Delmore Fast-Track

04/05/2026 – Auckland Council Response

Freshwater Ecology

Re: Freshwater Ecology Response Memorandum

Figure 1: Culvert 7 long section

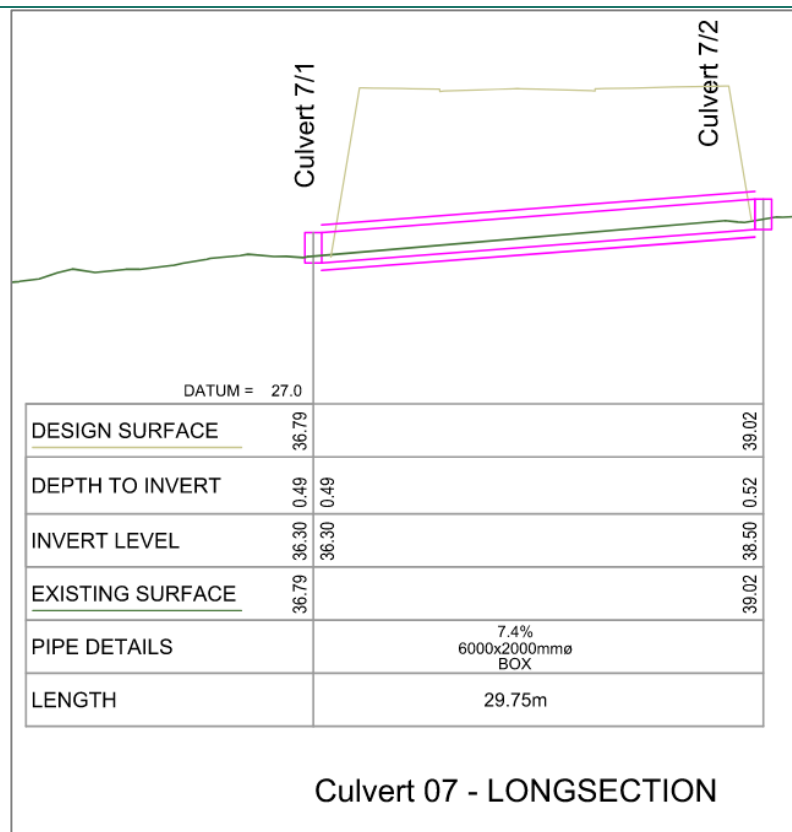
The applicant's ecologist has provided comments on fish passage at culverts 7 and 8 with steep gradients. I accept that similarly steep gradients in the proposed new culverts will provide equal fish passage and allow species which inhabit those sections of stream to migrate upstream.

- It is not clear that all culverts will be able to provide fish passage since slopes are not clearly shown to be in line with requirements in the New Zealand Fish Passage Guidelines (2024), particularly culverts 7 and 8 appear to have steep gradients.
- Embeddedness of culverts is not clearly shown on drawings, some culverts, (including 5, 8, 9 and 11 appear to be under the ground elevation.
- Plans for culvert 10 (drawing #3725-1-4810) indicate that temporary wetland loss and subsequent reinstatement will be

I note that culvert plans provided indicate pre and post development flow at the inlet and outlet of each culvert and that only culverts 2 and 5 have a notably higher post development flow (0.6 and 0.5m/s flow increase respectively). I accept the applicant’s ecologist’s response to fish passage concerns.
